LIC-16-0012  
April 4, 2016

Subject: License Amendment Request (LAR) 16-01; Revised Commitment to Modify FCS Plant Systems as Part of the Implementation of NFPA 805

License Amendment Request 16-01:

Revised Commitment to Modify FCS Plant Systems as Part of the Implementation of NFPA 805

FIGURE 1 FCS 125 VDC Distribution System

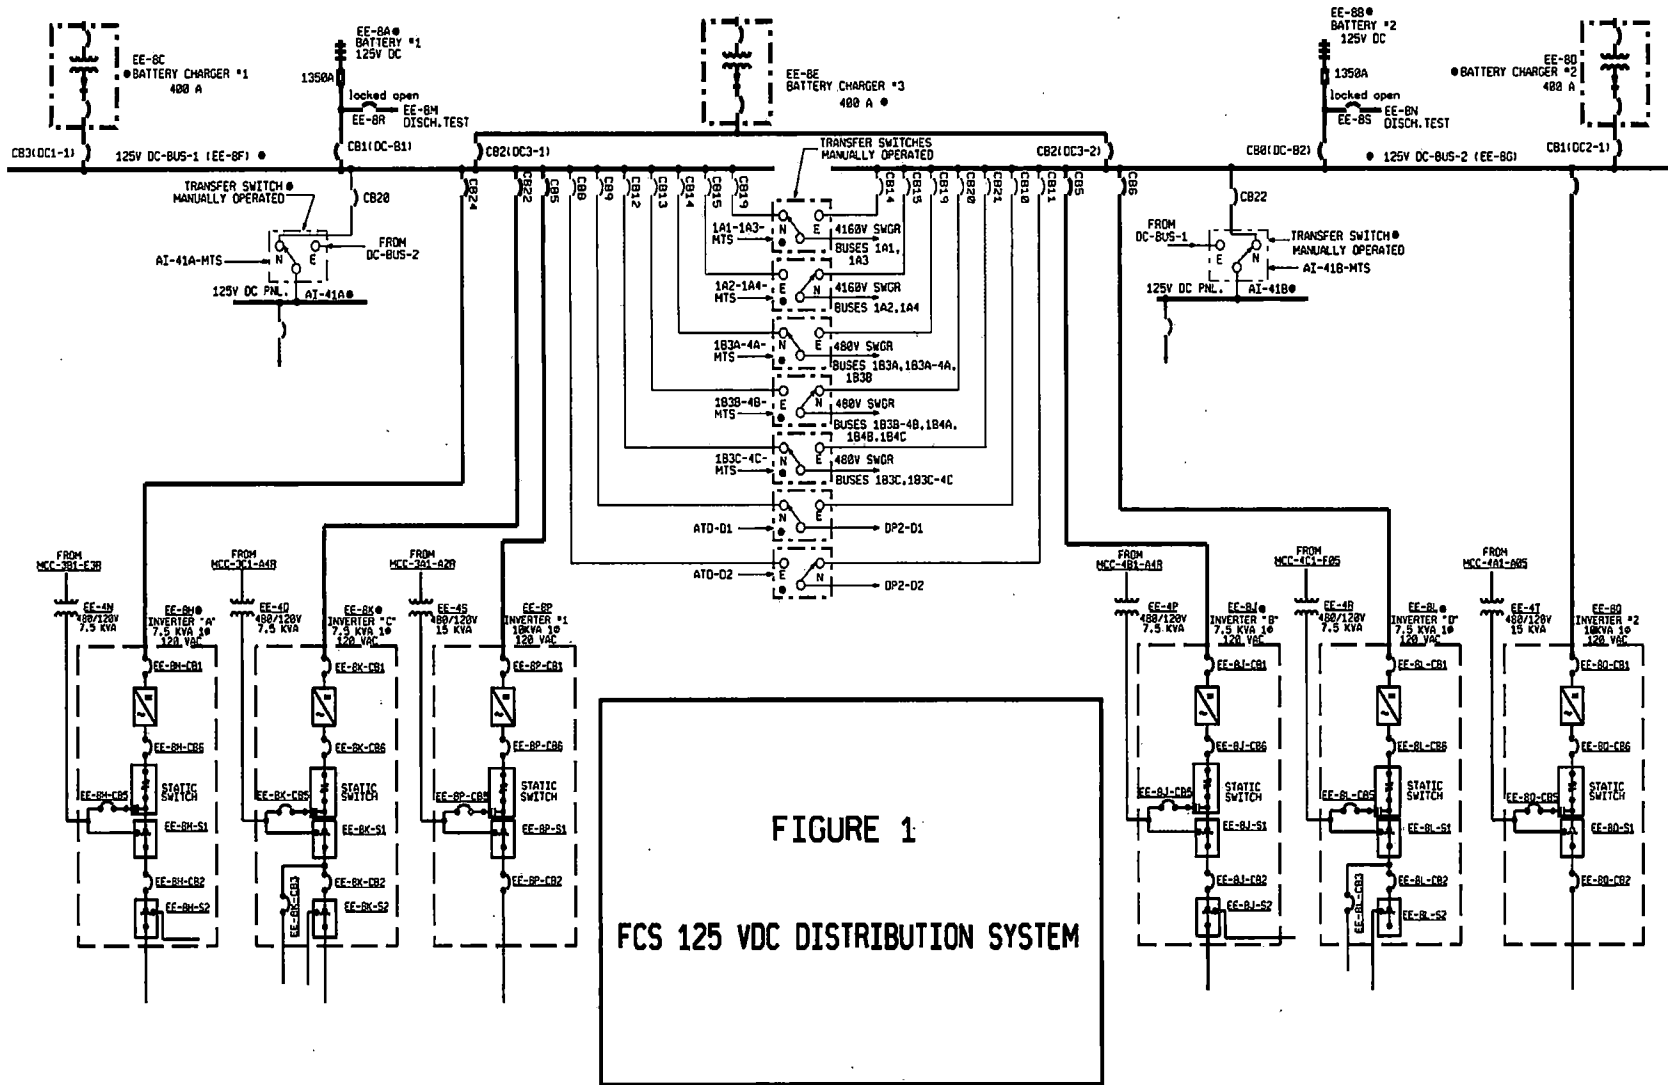
The FCS 125 VDC distribution system consists of two separate trains each of which has its own DC distribution bus, a battery which is connected directly to the bus and a battery charger powered from the associated 480 VAC train, also connected to the bus. The battery charger carries the DC load during normal plant operation while the battery is maintained in a standby condition ready to supply the bus in the event of a loss of battery charger operation or to supplement the battery charger during DC load transients. The system also includes a third battery charger that can be used to supply either DC bus from either train of 480 VAC power. The third charger is not normally in operation but can be manually placed in service during maintenance of train dependent chargers or in the event of charger failure.

Refer to Figure 1 for additional information regarding the DC system arrangement.

Each battery is connected to its associated DC distribution panel via a non-automatic circuit breaker (i.e. a manually operated switch) located at the DC distribution panel which is mounted in the associated train-dependent switchgear room.

Each DC bus normally provides power to three instrument inverters, two safety related and one non-safety related. Instrument inverters provide 120 VAC power to instrument buses for plant instrumentation and protective circuit components, including degraded-voltage relays. The instrument buses all have backup power capability from bypass transformers powered by the 480 VAC system. Each bypass transformer is placed in service by the operation of an automatic static switch in the event of associated inverter failure or loss of DC power to the inverter.

The DC buses also supply numerous other loads including control power for 480 and 4160 VAC circuit breakers, control room DC distribution panels and diesel generator starting and field flash circuits. Power to these loads is routed through manually-operated transfer switches that permit power to be supplied from either DC train. The transfer switches and the procedural direction for their use were both part of the original plant design. The transfer switches for control room DC distribution panels are located in the control room while other transfer switches are located near the associated loads. Power to DC controlled valves is provided from the main control room DC distribution panels, designated as AI-41A and AI-41B, associated with DC-Bus-1 and DC-Bus-2, respectively.
